Central Parc at North Port Pattern Plan Amendment

Petition No. PMCPA-24-00000114

Presented by: The Planning & Zoning Division

Request: Amend the Central Parc at North Port Pattern Plan to revise the buffer planting plan to remove plantings along the back of lakes adjacent to neighboring properties

Waiver Requests

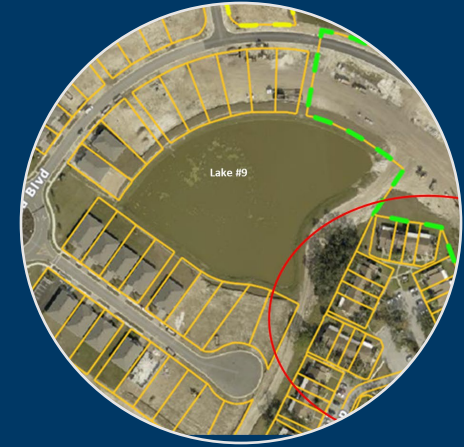
Waiver 1 - requests relief from ULDC Section 21-9, Table 1, Buffers, which requires a Type B buffer consisting of a 10' wide buffer with one tree every 50' and shrubs between the proposed Single-Family/Two-Family and existing multi-family. The waiver applies to approximately 450 feet of the boundary around Lake 5 between the Colony at Sabal Trace condominiums and Central Parc. The Applicant is requesting to eliminate any required plantings within the buffer adjacent to the lake, to allow the neighboring condominium residents an unobstructed view of the lake.

Waiver 2 - requests relief from ULDC Section 21-9, Table 1, Buffers, which requires a Type B buffer consisting of a 10' wide buffer with one tree every 50' and shrubs between the proposed Single-Family/Two-Family and existing multi-family. The waiver pertains to approximately 275 feet of the perimeter boundary between Fairway Villas and Central Parc, surrounding Lake 9. The Applicant is requesting to eliminate any required plantings within the buffer adjacent to the lake, proposing that existing preserved mature oaks in the buffer area provide needed buffering between the uses.

The request to eliminate plantings adjacent to Lake 5 is not supported. The 2010 ULDC requires a 10' Type B buffer where single-family/two-family residential is adjacent to multifamily uses. The approved Pattern Plan includes an enhanced buffer for added protection between different densities and heights. Retaining the enhanced buffer is essential for compatibility between current and future uses of the two districts.

The request to eliminate planting adjacent to Lake 9 is not supported. The 2010 ULDC requires a 10' Type B buffer in this location where single-family/two-family residential is proposed adjacent to existing multifamily uses. It is important to recognize that the adopted Pattern Plan has an enhanced buffer approved in this location providing additional protection between uses of varying density and heights. To ensure compatibility between current and future uses of the two districts, the enhanced buffer should be retained.

Central Parc Proposed Buffers

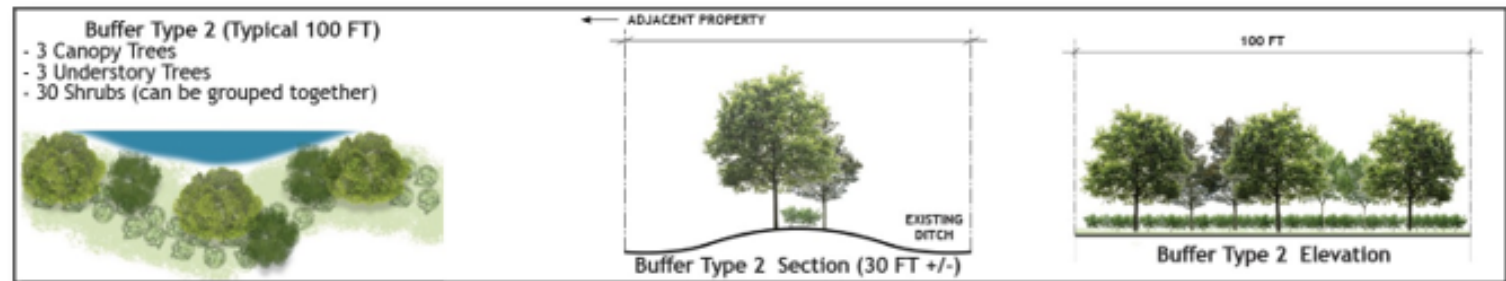
Proposed Buffer Type 2 - is a 30' wide open space area having 3 canopy trees, 3 understory trees, 30 shrubs every 100' on a small berm. The shrubs can be grouped together. This buffer type is located at the property line between the lakes and the adjacent residential properties. The berm has been removed with the proposed amendment, and the elevation relates to an existing ditch.

Staff also believes that the intent to provide views of the lake can be met by simply updating the Type B buffers to exclude the required berm and shrubs. Three (3) canopy trees and three (3) understory trees every 100 linear feet will not create visual barriers, and in fact, may create more scenic views of the lake, provided that the planting style is staggered and randomized to provide a less curated appearance.

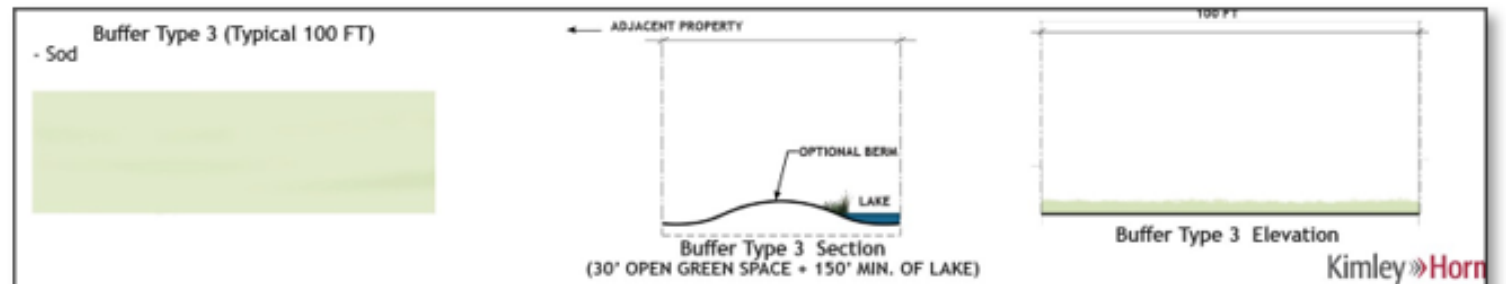
Proposed Buffer Type 3 - is a 30-foot wide open space featuring sod and an optional berm. The sod will be placed in locations where the lake adjoins residential and mixed-use areas 1 and 2.

The Board voted unanimously, 7-0, to recommend approval of Petition No. PMCPA-24-00000114 (Formerly DMA-24-114) via Ordinance No. 2025-28 as presented by the applicant, without the grant of Waivers 1 and 2, and the change proposed to the buffer adjacent to Lake 13. Buffers adjacent to Lakes 5, 9, and 13 shall meet the planting/screening specifications of a Type 2 buffer.

Option 1: Approve the amended buffer plan as presented by the Applicant, without the grant of Waivers 1 and 2, and the change proposed to the buffer adjacent to Lake 13. Buffers adjacent to Lakes 5, 9, and 13 shall meet the planting/screening specifications of a Type 2 buffer.
